**Summary of Issues Related to Development of Lot 87,
8133 Mansion Hill Avenue, Midtown Commons**

RE: Letter of Intent
Lot 87, Midtown Commons Plat
Madison, WI
SIP Submittal

Response to committees 10/22 comments:

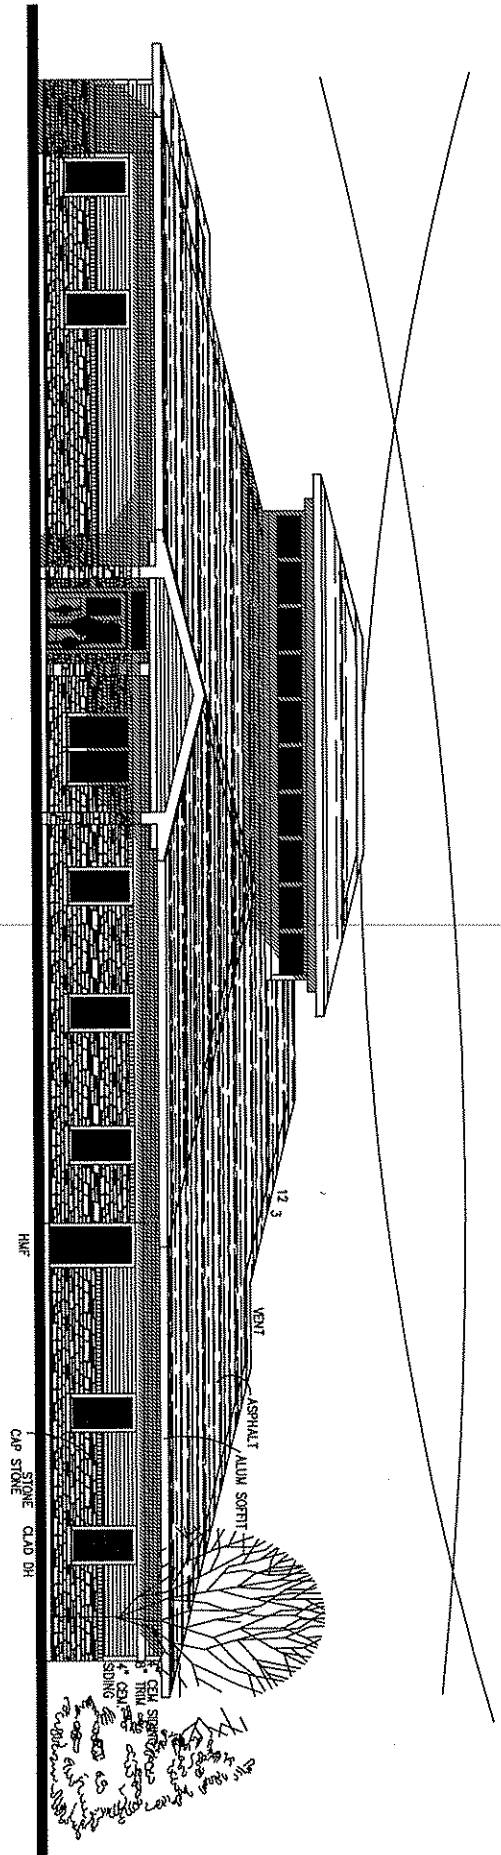
Response to City Staff Comments

Response to Neighbors from 2 meetings

- 1) More screening has been added per the discussion
- 2) The dumpster enclosure has been included, using materials from the building
- 3) Access to shared driveways will remain open for residents of buildings on adjacent properties throughout the duration of the construction process.

- 4) The Daycare building will assume liability for repairing any damage to adjacent properties that occurs during the construction process.
- 5) The applicant shall **has** installed sidewalk from Starr Grass Drive to Mansion Hill Avenue.

- 6) The applicant ~~shall~~ **has** relocated the proposed crossing of the parking lot to accommodate for loading area not to end the crosswalk in a parking space. In addition, the applicant shall **has** installed ramps and crosswalks for the sidewalk walk connection between Starr Grass Drive and Mansion Hill Avenue.

- 7) A "Stop" sign shall be installed at a height of seven (7) feet at all driveway approaches
- 8) A parking stall has been eliminated at the dead ends

1. Protection of an existing retaining wall belong to the building to the East will be provided as well as a 3' fence. Add evergreen landscape screening at the same line
- 2) All snow plowing on shared easement property will be accomplished and paid for by the Daycare building
- 3) We have agreed, at our expense, to relocate the mailboxes for building "88" at a location of their choice on their property.
- 4) Add striping in the crosswalk across both drive accesses
